# Zoning Map Amendment

CITY OF VENICE  
Planning and Zoning Division  
Staff Report

**Application Date:** October 6, 2017  
**Project Name:** SJMR (PUD)  
**Petition Number:** 17-13RZ  
**Property Owner:** Pamlico Point Management, LLC.  
**Agent:** Jeffrey A. Boone, Esq.

**MAP A: Conceptual Site Plan (Binding Master Plan)**

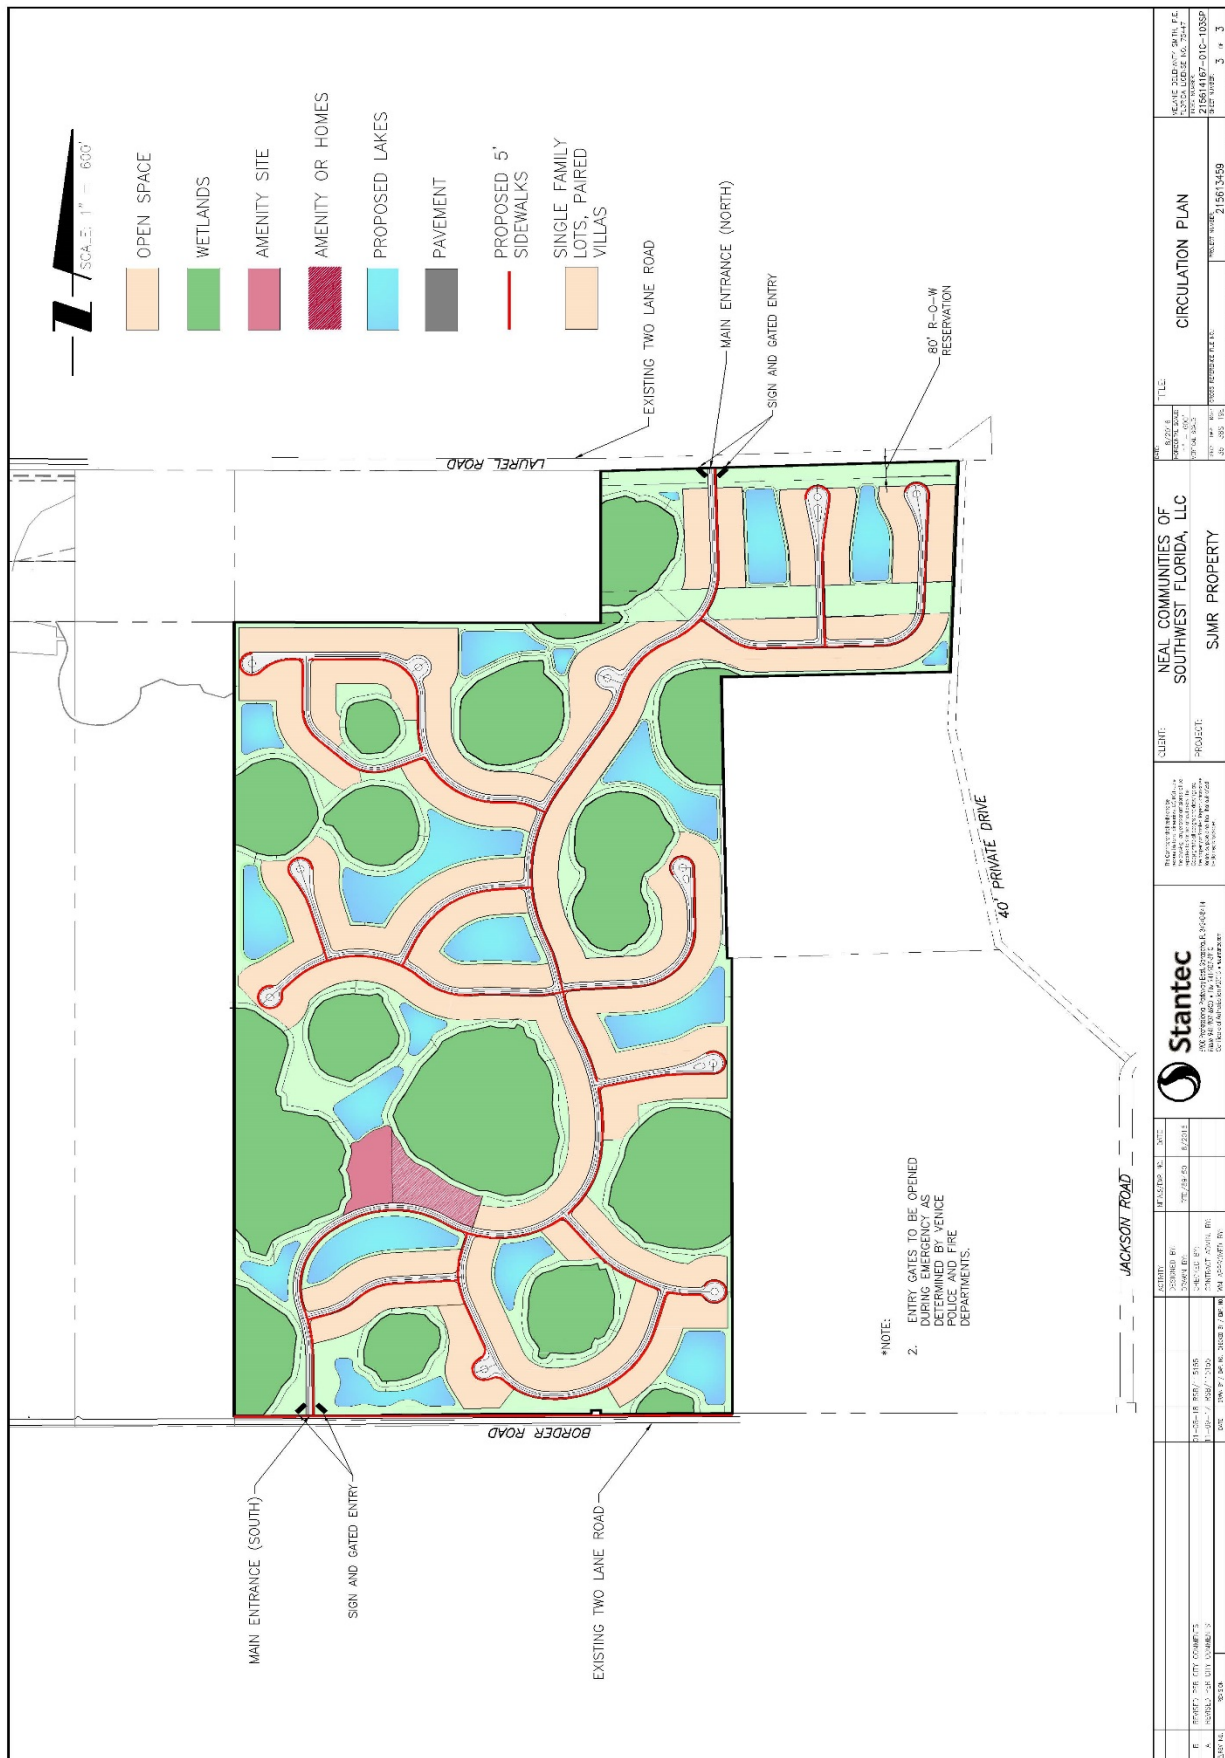
Staff comment: Generally (upon review of the SJMR PUD conceptual site plan – see Map A), it is noted that the proposed PUD proposes a compact lot design, clustering development areas while preserving and adding to connectivity of the wetland areas to facilitate habitat connectivity. The PUD design utilizes natural features of the land promoting retention and viability of the natural environment including wetlands and habitats consistent with Strategy LU 1.3.5.

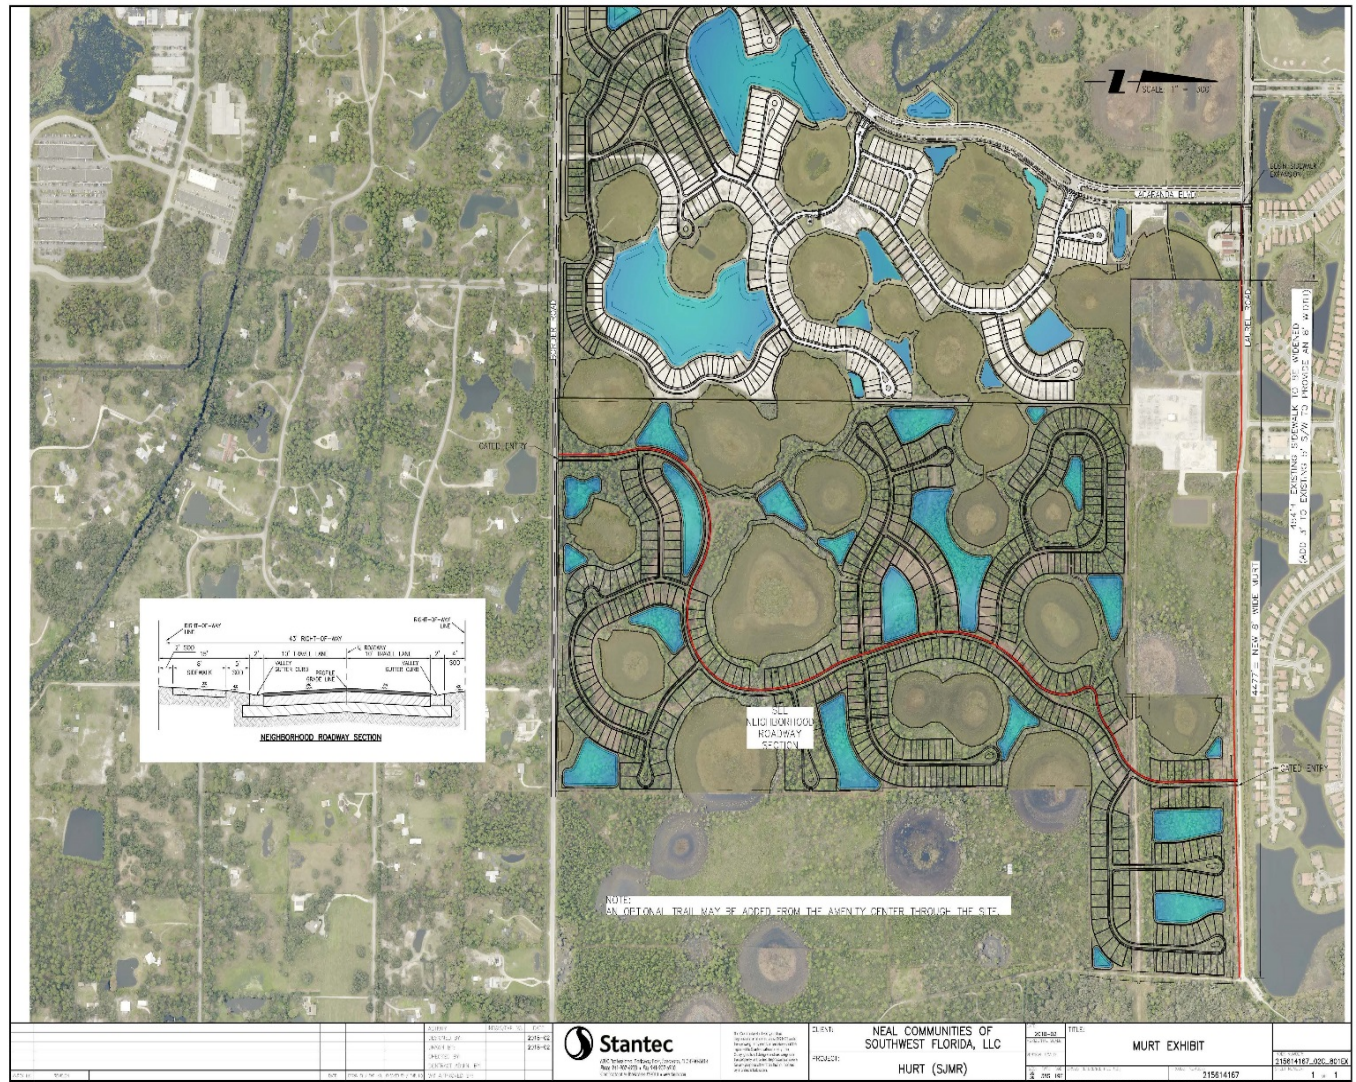
*Staff Comment: related to #2 above a reduced ROW based upon the reduction of sidewalks would be appropriate. The proposal provides for a curb and gutter style roadway design and no comments were received from the City Engineering department on this issue.*
